Accessibility Survey

City of Downey Carfax Avenue - Cul-de-sac to Foster Road

Date of Inspection
12/12/2016

Sidewalk South Of Cul-de-sac @ 33.913346505482, -118.112554550171

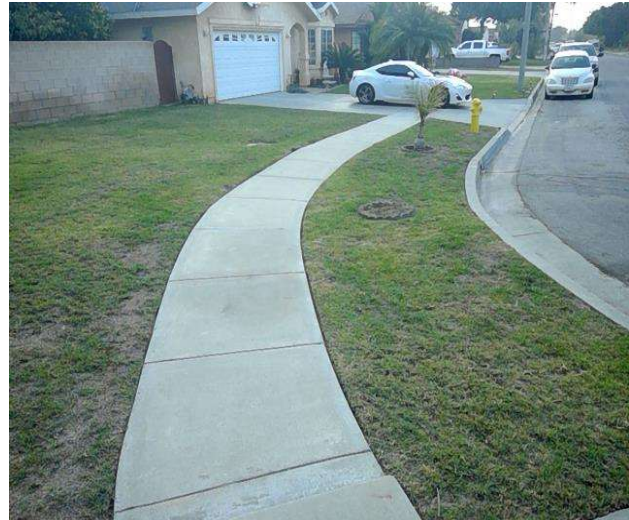
Sidewalk cross slope is not compliant.

On-Site Finding 5.20 percent for 45.00 feet

Repave the sidewalk surface with the recommended cross slope.

Recommendation Up to 2.08 percent
